VOLKSWAGENWERK AG
Service Department

Workshop Bulletin

No. **57**

Four-point bearing

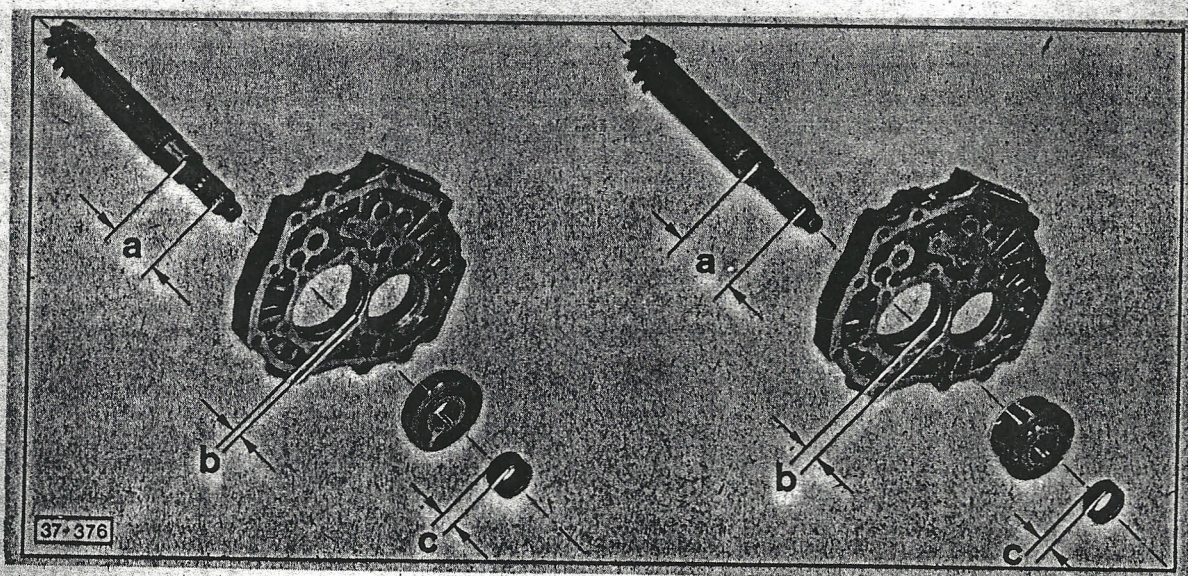
From Ch. No. 0871 000 334 or Transmission No. 38 348 the four-point bearing (Part No. 672-10-238-01/000) has been replaced by a double taper roller bearing (Part No. 014 311 375 A).

This has also involved modifications to the following parts:

<u>Old:</u>	<u>New:</u>
Intermediate housing	072-10-01-071/000	072-10-02-071/000
Pinion shaft with crown wheel	672-10-801-02/000	672-10-801-03/000
Spacer tube	072-10-00-089/000	072-10-01-089/000

In the case of vehicles before the Ch. No. or Transmission No. given above, the double taper roller bearing can only be installed together with the modified parts listed.

Old

New

<u>Old</u>	<u>New</u>
- a -	53.7 mm	67.5 mm
- b - (depth of recess)	6.6 mm	10.7 mm
- c -	18.5 mm	13.5 mm
